# CHANGE ORDER

<input checked="" type="checkbox"/> <b>ORDERED BY ENGINEER UNDER SECTION 1-04.4 OF THE STANDARD SPECIFICATIONS.</b> <input type="checkbox"/> <b>CHANGE PROPOSED BY CONTRACTOR</b>	<b>PROJECT IDENTIFICATION</b> <b>PROJECT NAME:</b> 36 <sup>th</sup> Avenue W & 35 <sup>th</sup> Avenue W, 164 <sup>th</sup> St SW to SR 99 <b>PROJECT NUMBER:</b> RC1783, RC1784, RR6337, RR6342, UPI 06-0014 Fed Aid #: STBGUL-2585(001)
<b>CONTRACTOR ENDORSEMENT:</b> <div style="display: flex; align-items: center;"> <div style="flex: 1;"> <p><b>Kenton Wilde</b></p> <p style="text-align: center;">SIGNATURE</p> <p>Vice President</p> <p style="text-align: center;">TITLE</p> </div> <div style="flex: 0.5; font-size: 8px; border: 1px solid black; padding: 2px;">         Digitally signed by Kenton Wilde          DN: C=US, E=kenton@marshbankconst.com, O=Marshbank Construction Inc, CN=Kenton Wilde          Date: 2025.04.23 07:53:55-0700'       </div> <div style="flex: 1;"> <p style="text-align: center;">DATE</p> </div> </div>	<b>CONTRACTOR:</b> Marshbank Construction, Inc.  <b>ADDRESS:</b> PO Box 97 3304 Old Hartford Rd Lake Stevens, WA 98258

CHANGE ORDER #11 4/1/2025 Page 3 of 5
---

REFERENCE SHEET NO: DR05  
 SHEET 74 OF 163 SHEETS

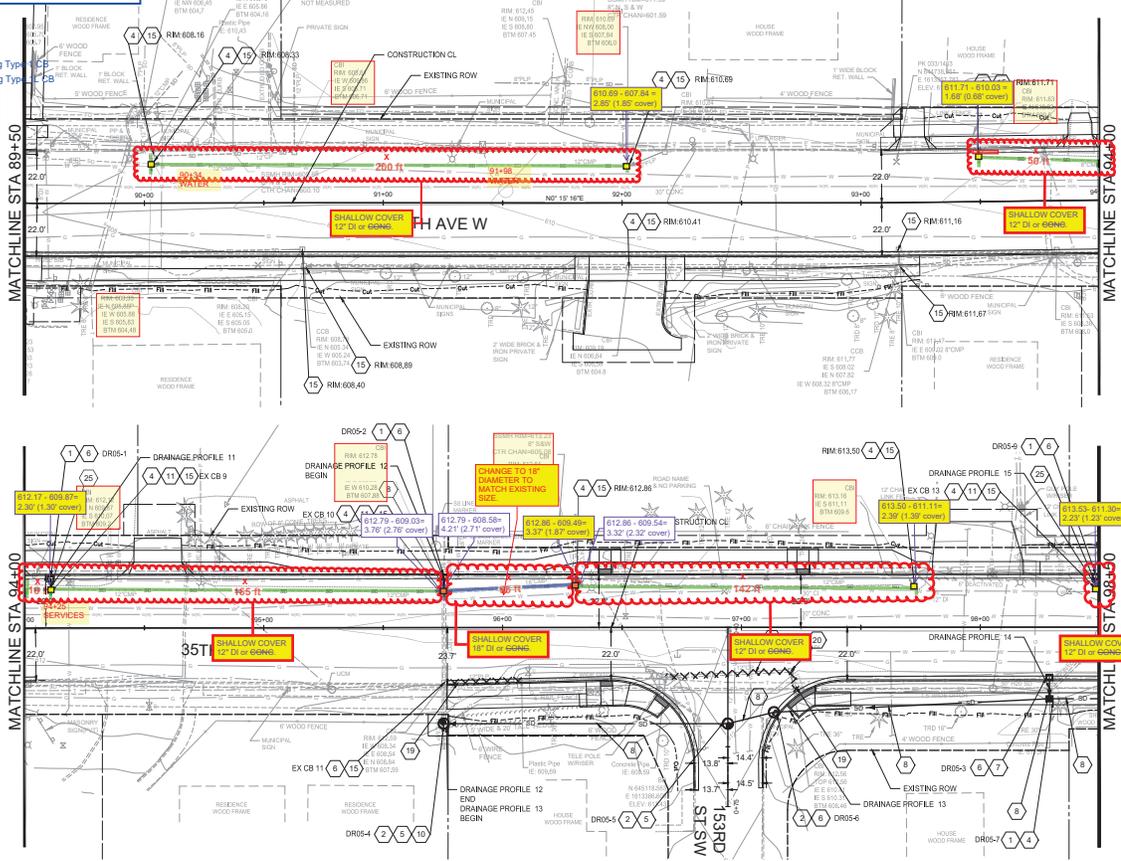
This Change Order compensates the Contractor for removing and replacing existing storm drainage pipe runs and catch basins from Station 94+00 to 110+30 and as shown on revised plan sheets DR05 through DR07. Prior to removal, the Contractor shall record existing rim and invert at existing catch basins and reinstall the new storm drainage to match the existing invert elevations and pipe run slopes.

Removing Drainage Structure and Removing Existing Pipe includes the removal and disposal of catch basins and storm drain pipes where new catch basins and pipes are shown on the revised plan sheets DR05 through DR07, or where designated by the Engineer.

Existing GREEN LINE = 12" CMP  
 Existing BLUE LINE = 18" CMP

**Ductile Replacement**  
 = Replace Existing Type  
 = Replace Existing Type  
 MAINTAIN EXISTING ELEVATIONS FOR REPLACEMENT PIPE AND STRUCTURES

REFERENCE SHEET NO. DR06  
 SHEET 75 OF 163 SHEETS

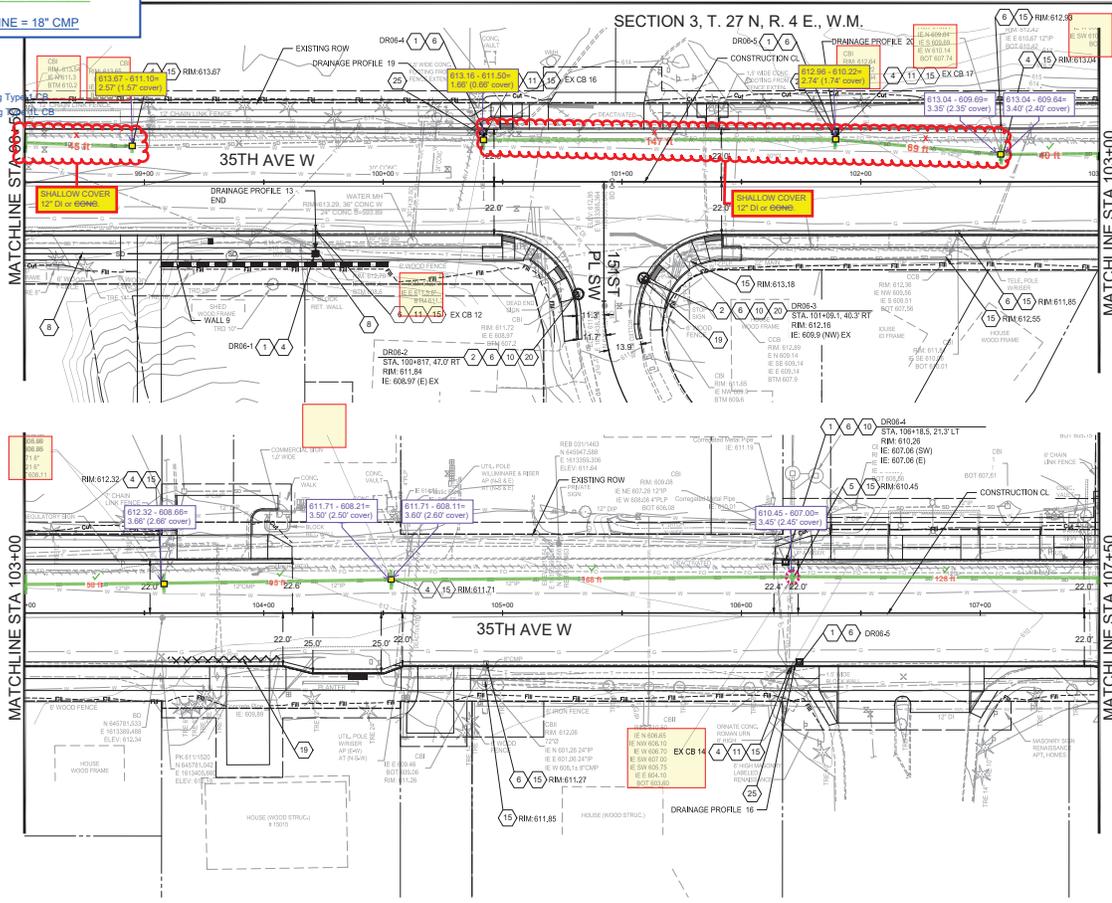
Existing GREEN LINE = 12" CMP  
 Existing BLUE LINE = 18" CMP

Ductile  
 Replace

Replace - Existing Type  
 Replace - Existing Type

MANTAIN EXISTING ELEVATIONS FOR REPLACEMENT PIPE AND STRUCTURES

REFERENCE SHEET NO:	D007
SHEET	76
OF	163
SHEETS

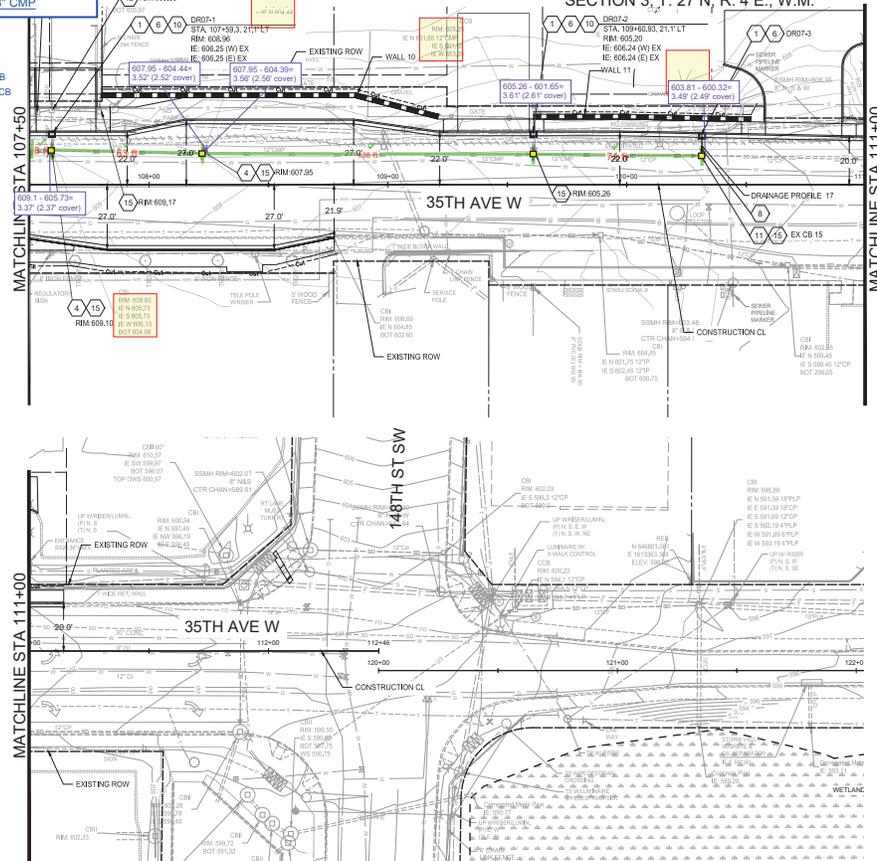
Existing GREEN LINE = 12" CMP  
 Existing BLUE LINE = 18" CMP

**Ductile Replacement**

■ Replace Existing Type 1 CB  
■ Replace Existing Type 1L CB

MAINTAIN EXISTING ELEVATIONS FOR REPLACEMENT PIPE AND STRUCTURES
